CONSTRUCTION QUALITY ASSURANCE

ON-SITE DISPOSAL FACILITY

PHASE II CELL 2

APPENDIX S:
REQUEST FOR CLARIFICATION
OF INFORMATION (RCI)
OSDF Phase II Cell 2 (20102)

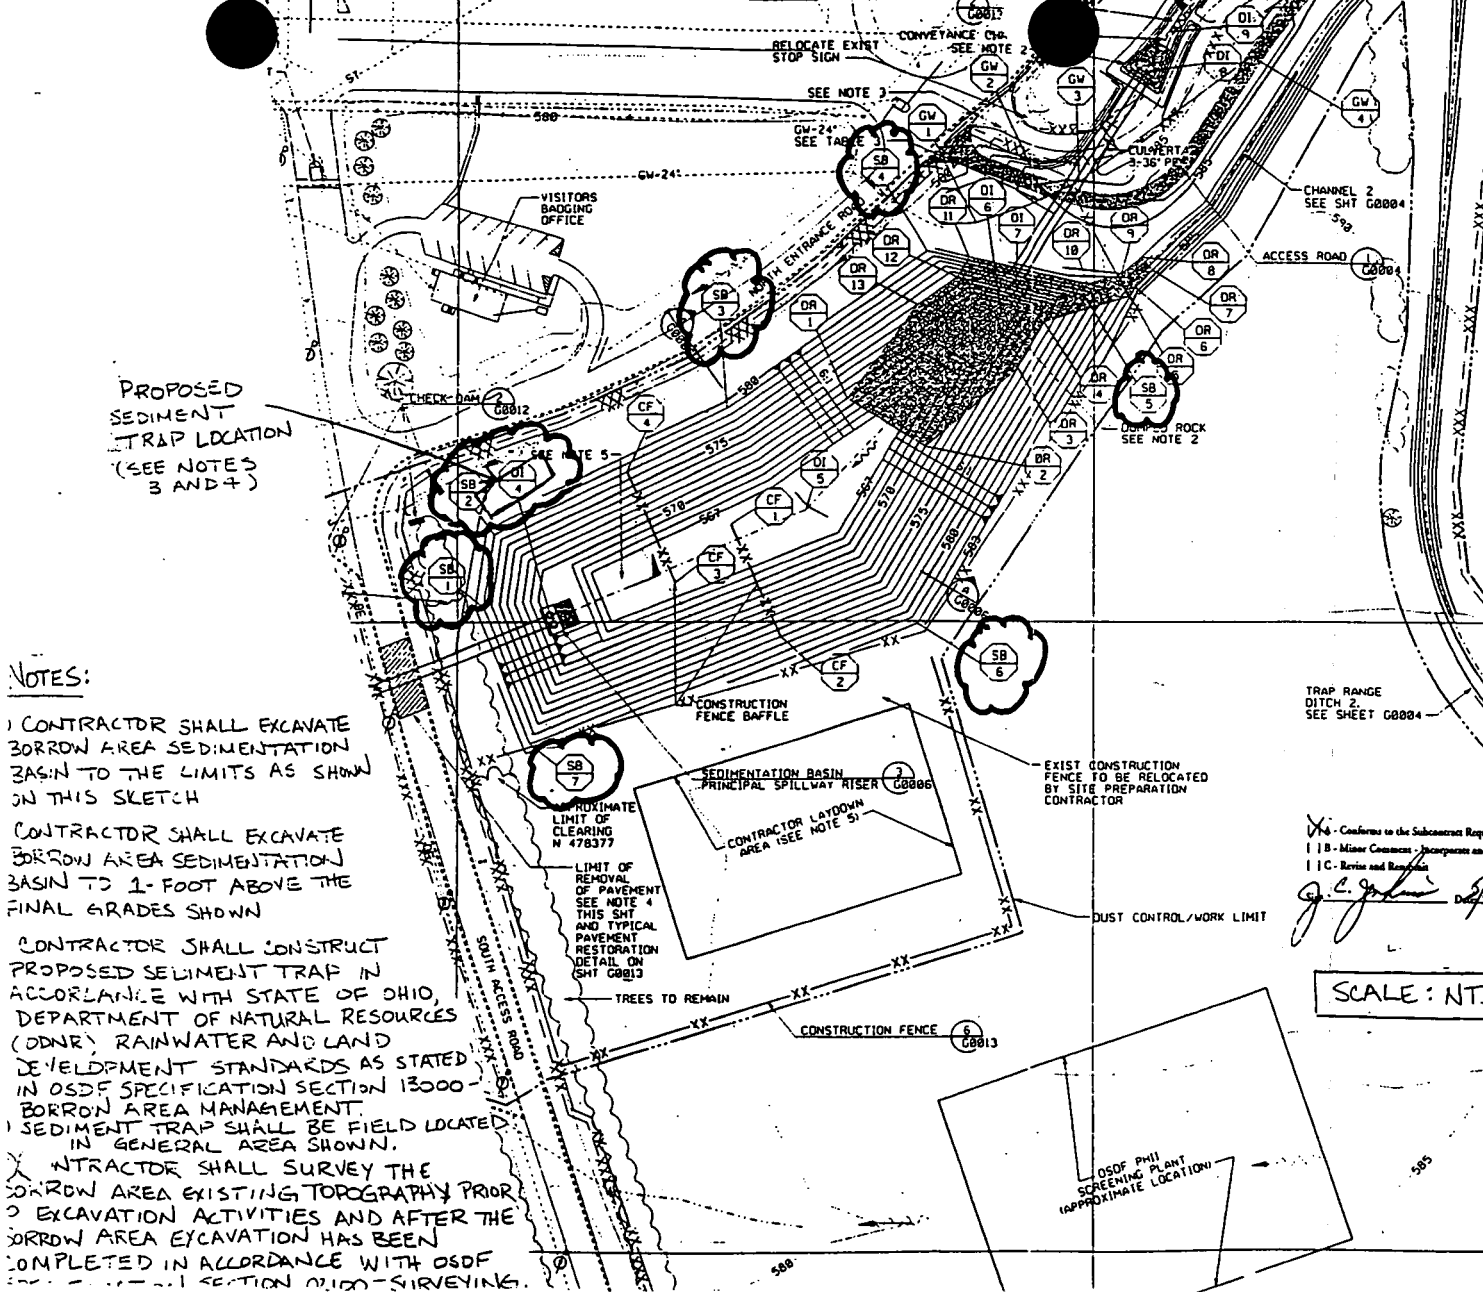
(9) <input checked="" type="checkbox"/> RCI - INQUIRY <input type="checkbox"/> USQD SCREENING BY PROJECT ENGINEER			(9) <input type="checkbox"/> DCN - JUSTIFICATION, EXISTING CONDITION & REQUESTED/PROPOSED CHANGE		
<p>The Phase II OSDF contract states the OSDF contractor is to excavate the Borrow Area Sedimentation Basin prior to commencement of Borrow Area activities. The attached sketch 20102-SK-002 shows in plan view the limits of excavation for the sedimentation basin.</p> <p>The OSDF Contractor shall excavate clay liner soil material from the borrow area to elevations approximately 1-foot above the sedimentation basin final grades shown on the sketch.</p> <p>The OSDF Contractor shall survey the borrow area existing conditions prior to excavation activities and after the borrow area excavation has been completed in accordance with OSDF Specification Section 02100 - Surveying.</p>			<p>A proposed sediment trap shall be field located in the general area shown on the sketch. The Contractor shall construct the sediment trap in accordance with State of Ohio, Department of Natural Resources (ODNR), Rainwater and Land Development Standards as stated in OSDF Specification Section 13000 - Borrow Area Management.</p>

INFORM ON					
(10) REQUESTOR: MAUREEN RICHARD		COMPANY: FDF		DATE: 05/14/98	(12) CE / PE DONALD B. GOETZ JAMES C. JENKINS
(13) RESPONSE: FOR RCI, IS A DCN REQ'D? <input checked="" type="checkbox"/> NO <input type="checkbox"/> YES		(14) FOR DCN: <input type="checkbox"/> APPROVED <input type="checkbox"/> APPROVED AS NOTED <input type="checkbox"/> DISAPPROVED			
RCI - DCN ACCEPTANCE

REROUTING OF BORROW
AREA HAUL ROAD

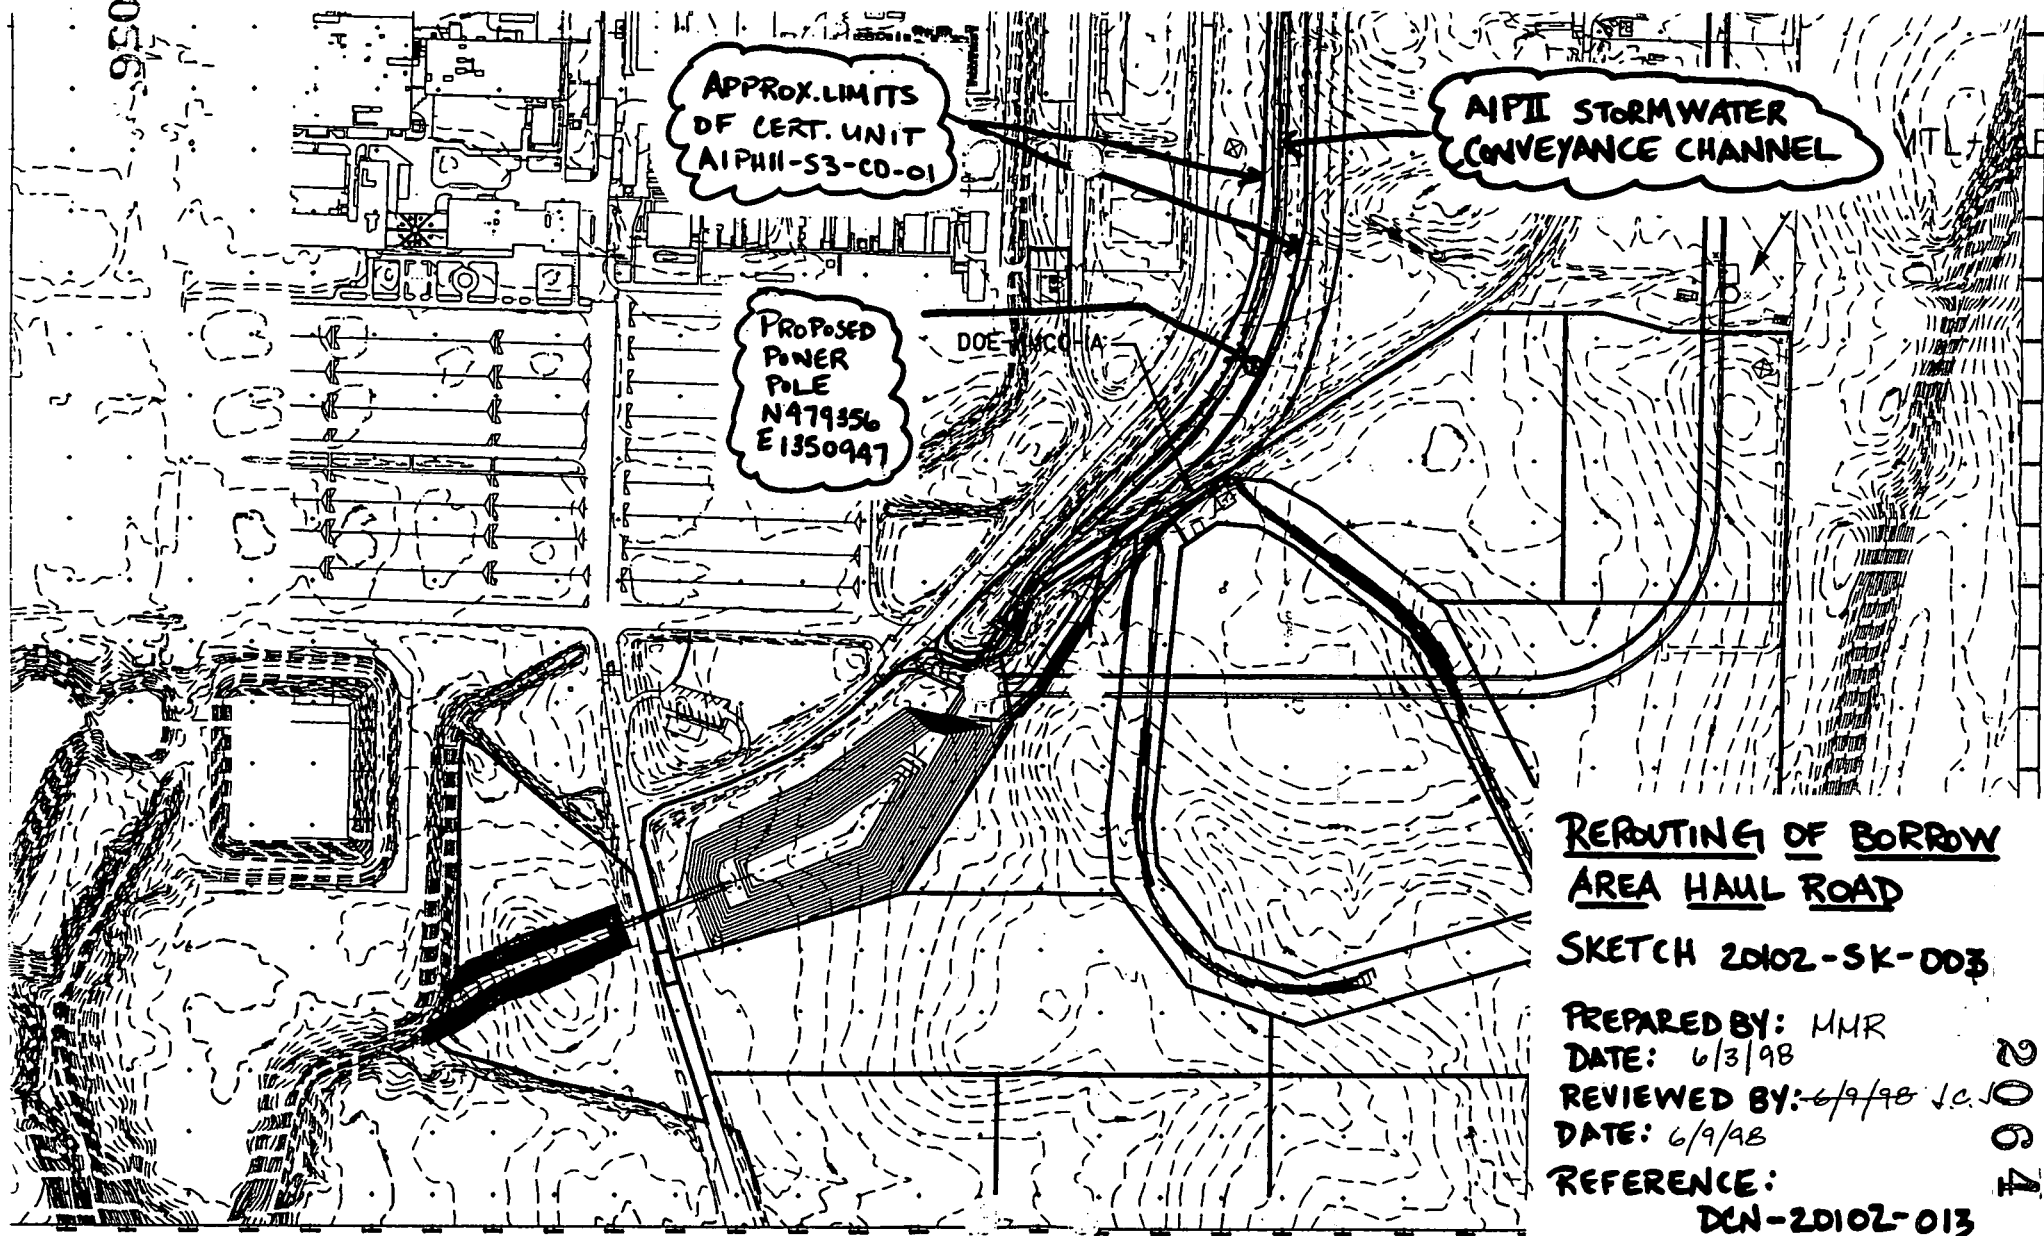
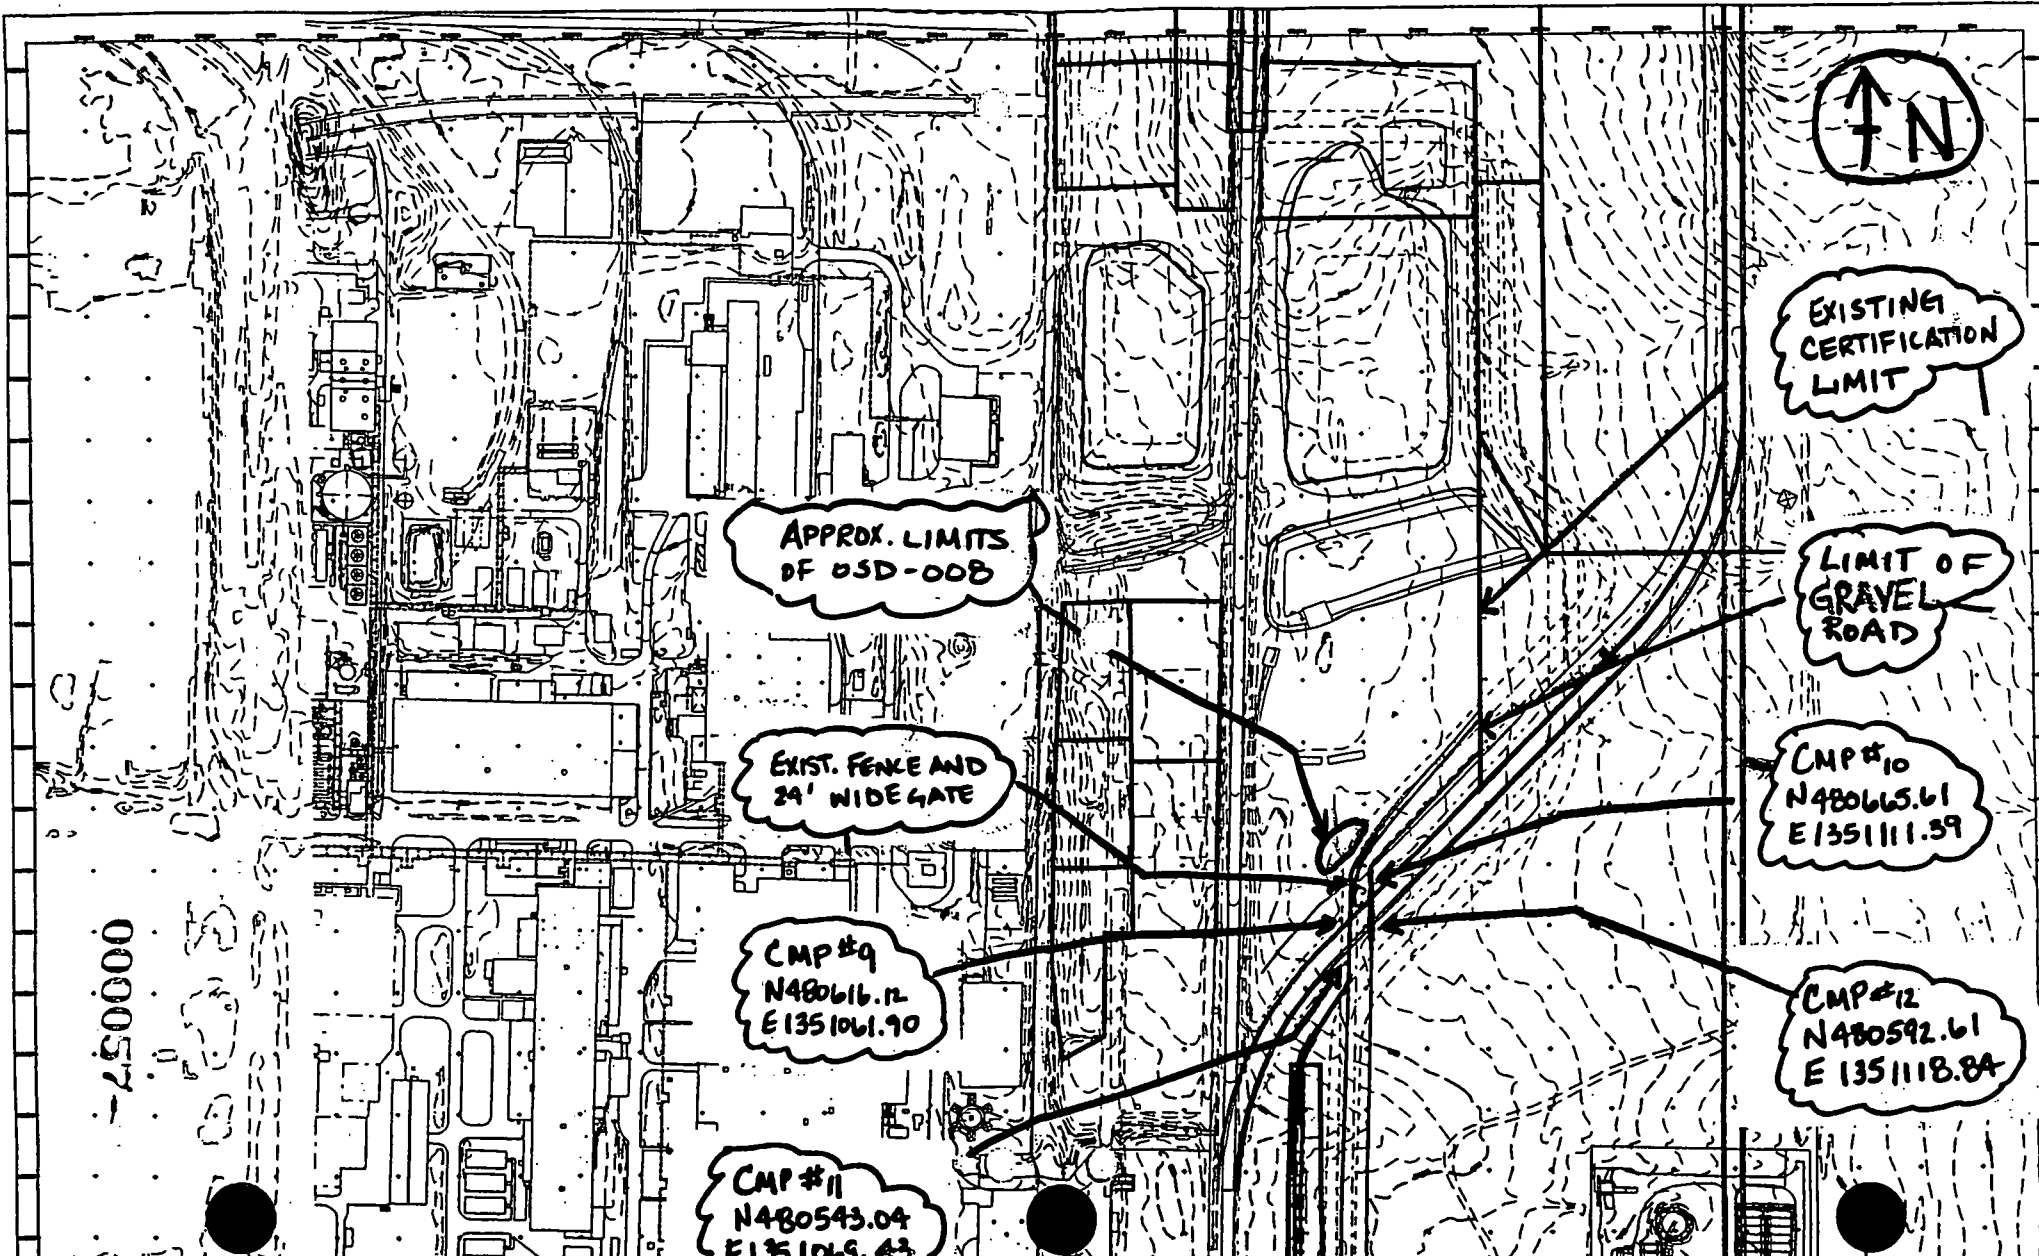
(9) <input type="checkbox"/> RCI - INQUIRY <input type="checkbox"/> USQD SCREENING BY PROJECT ENGINEER			(9) <input checked="" type="checkbox"/> DCN - JUSTIFICATION, EXISTING CONDITION & REQUESTED/PROPOSED CHANGE		
<p>REROUTE OSDF BORROW AREA HAUL ROAD AS SHOWN ON SKETCH 20102-SK-003. THE NEW LOCATION TO THE SOUTH MAY USE THE EXISTING DITCH CROSSING AND STP ACCESS ROAD AND BE ROUTED AROUND THE LOCATION FOR A PROPOSED POWER POLE (N479356, E1350947).</p> <p>THE NEW LOCATION AT THE NORTHERN END OF HAUL ROAD WILL MAKE USE OF EXISTING GATE AND ROAD CROSSING OF THE NEW NORTH ENTRANCE ROAD TO REDUCE THE LENGTH OF THE HAUL ROAD, WHICH WILL MINIMIZE ROAD CONSTRUCTION. THE NEW LOCATION OF THE HAUL ROAD SHOULD BE ROUTED TO AVOID DISTURBANCE OF STOCKPILE MTL-OSD-008 IF PRACTICAL.</p>			<p>THE NEW LOCATION OF THE HAUL ROAD SHOULD BE ROUTED SO AS NOT TO DISTURB THE PROPOSED A1P11 STORMWATER CONVEYANCE CHANNEL LAYOUT LOCATED IN CERTIFICATION UNIT A1P11-S3-CD-01.</p> <p>ECDC CONTROLLED COPY NO 1 1</p>

TEMPORARY ACCESS RAMP INTO CELL 2

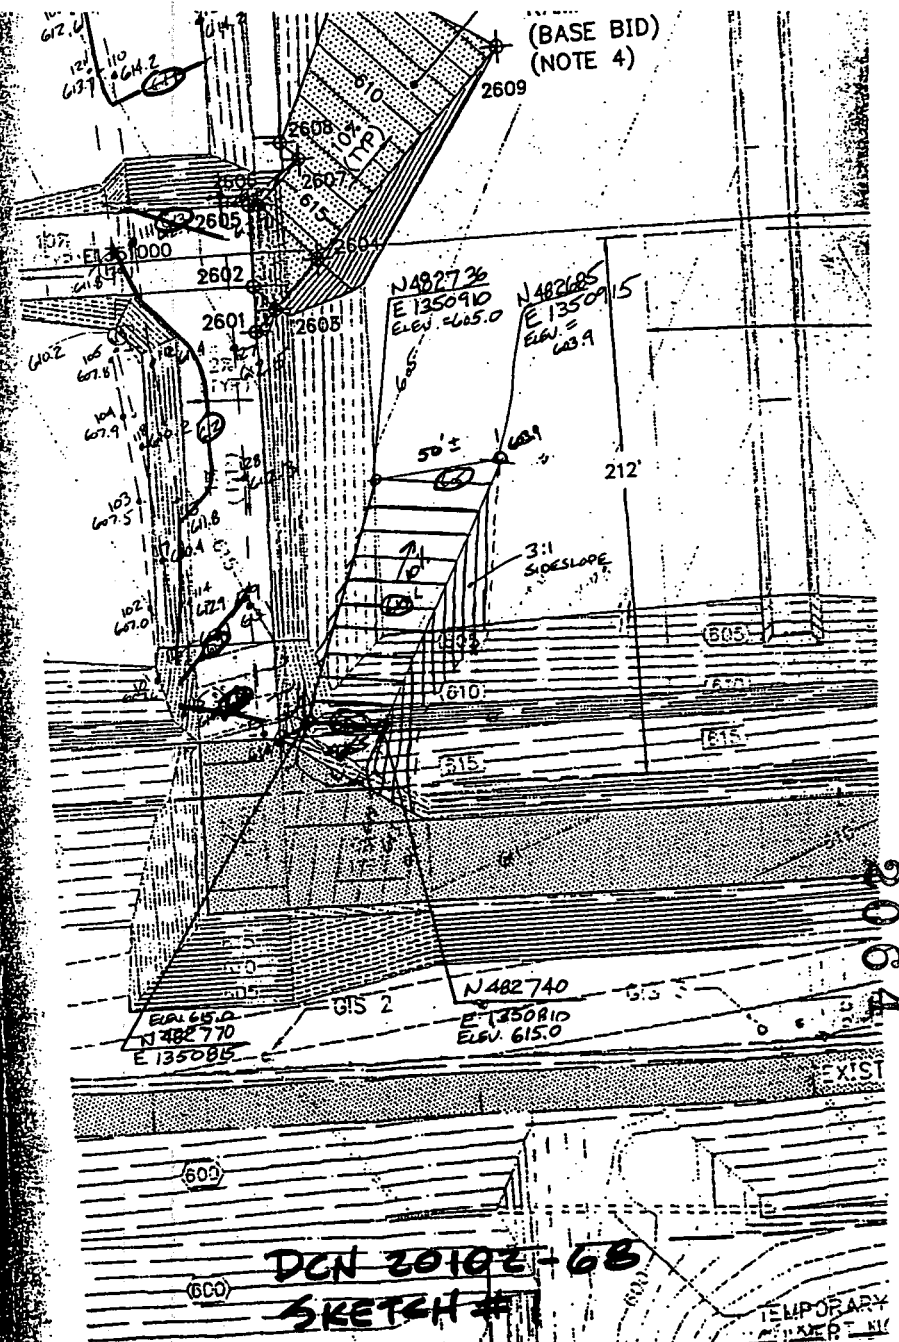
RCI 20102-37R EXISTING ACC

1. FIELD VERIFICATION SHALL BE PERFORMED PRIOR TO CONSTRUCTION OF RAMP
2. RAMP MUST BE A MINIMUM OF 3 FEET ABOVE GEOMEMBRANE LINER.
3. COORDINATES SHOWN ARE APPROXIMATE.
4. FIELD VERIFICATION OF ALIGNMENT OF EXISTING ACCESS ROAD IS TO BE PERFORMED TO DETERMINE PROPER TURNING RADIUS.
5. THIS RAMP IS TEMPORARY. THE CLAY WEDGE SHALL BE CONSTRUCTED UPON COMPLETION OF RAMP USE AND OR AS APPROVED BY CONSTRUCTION MANAGER.
6. STONE SURFACE TO BE INSTALLED AT TOP OF RAMP (25' LENGTH (MIN)) WITH ODOT 304 OR APPROVED EQUIV. (6"-8" DEPTH MIN.) ELEVATION 615.0 TO 615.5.
7. RAMP SKETCHED REPLACES CELL 2 ACCESS RAMP NO. 1 AS SHOWN ON PHASE II CONSTRUCTION DWGS, DWG. 90X-6000-G-00222 AS PREPARED BY GEOSPINTEC CONSULTANTS.
8. RAMP PORTIONS ABOVE SELECT AND CLAY LINER MATERIAL ZONES SHALL BE COMPACTED TO 95% RHD.

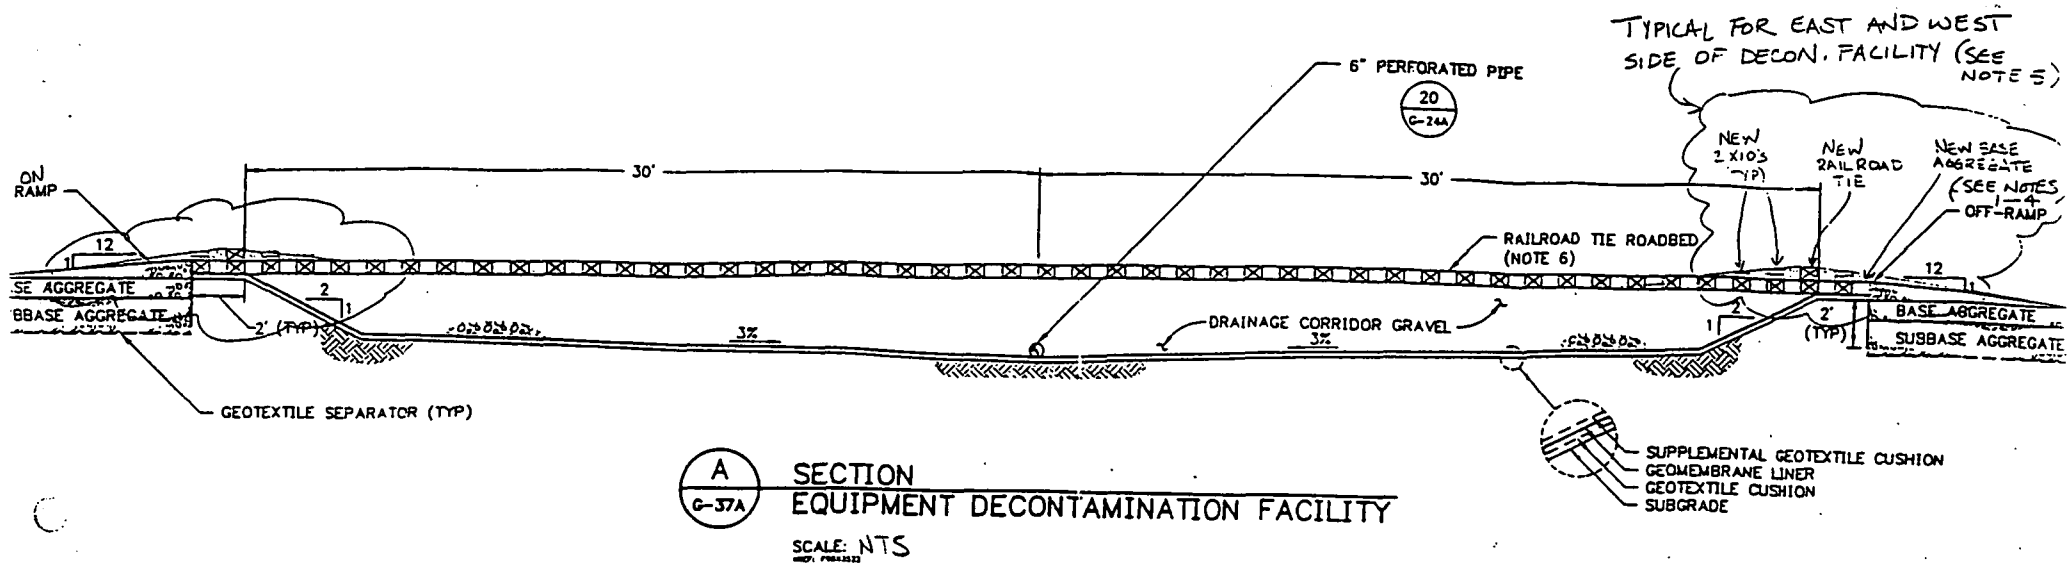
(9) <input type="checkbox"/> RCI - INQUIRY <input type="checkbox"/> USQD SCREENING BY PROJECT ENGINEER			(9) <input checked="" type="checkbox"/> DCN - JUSTIFICATION, EXISTING CONDITION & REQUESTED/PROPOSED CHANGE		
<p>CONSTRUCT AGGREGATE BERMS AT THE EAST AND WEST ENDS OF THE DECONTAMINATION PAD AS SHOWN ON SKETCH 20100-SK-013 AND SKETCH 20100-SK-012. LEAVE A TWO (2) FOOT MINIMUM OPENING IN THE NORTH END OF THE WEST BERM TO ALLOW RUNOFF FROM THE IMPACTED MATERIAL HAUL ROAD TO DRAIN INTO THE DECONTAMINATION FACILITY.</p> <p>GRADE THE IMPACTED MATERIAL HAUL ROAD SURROUNDING THE DECONTAMINATION FACILITY TO DRAIN INTO THE FACILITY. SEE ATTACHED SKETCH 1702-SK-001, REVISION 1.</p> <p>CHANGE SECTION A/G-37A ON EQUIPMENT DECONTAMINATION FACILITY DETAILS (SHEET G-37A) AND IMPACTED MATERIAL HAUL ROAD GRADING PLAN (SHEET G-14A) TO REFLECT CHANGES ON ATTACHED SKETCHES.</p>					
<p style="text-align: center;">ECDC CONTROLLED</p> <p style="text-align: center;">COPY NO.</p> <p style="text-align: center;">RECEIVED</p> <p style="text-align: center;">JUN 24 1998</p> <p style="text-align: center;">KBT</p> <p style="text-align: right;">05/27/98</p>

1. Use ODOT 304 Aggregate for the New Base Aggregate noted on DCN Sheet 3.
2. Sketch 1702-SK-001, DCN Sheet 4, base drawing is not the latest revision. See Response to DCN 1702-047 and Rev. 0, Drawing 90X-6000-G00199.
3. Aggregate berms may require significant maintenance or replacement from time to time especially after undergoing freeze thaw cycles.
4. Submit detail of 2-foot gap that is intended to collect and transfer drainage into facility. A gratted box culvert or pipe located at the north side of the northwest corner may be more suitable.
